Access Compliance Report

Public Rights-of-Way

(Pedestrian Signals)

Intersection ID: N/A	Main Street:	Cross Street: N/A	Location: N/A
ADA ID: 0E7E03F00D39	Signal Type: One Push Button-Non APS	Overall Compliance: No	Severity Score: BTN 1: N/A BTN 2: N/A No BTN: N/A
Codes/Mitigation Info/Possible Solution		Field Measurements/Component Compliance

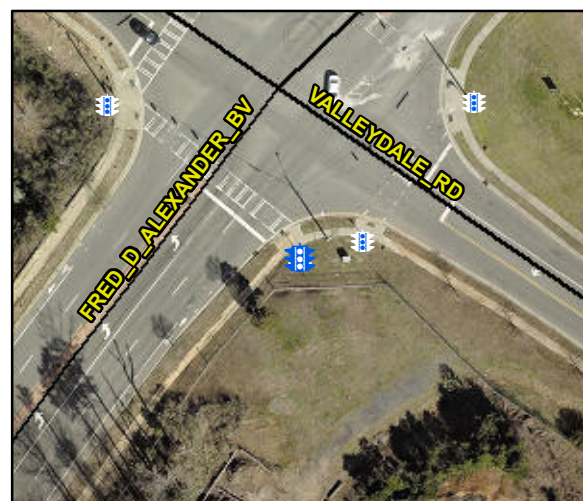
PROW/ADA: TMUTCD 4e.08, R404.7.2

Possible Solutions: Replace Signal Push Button With APS Button on New Post. Remove & Relocate Sign.
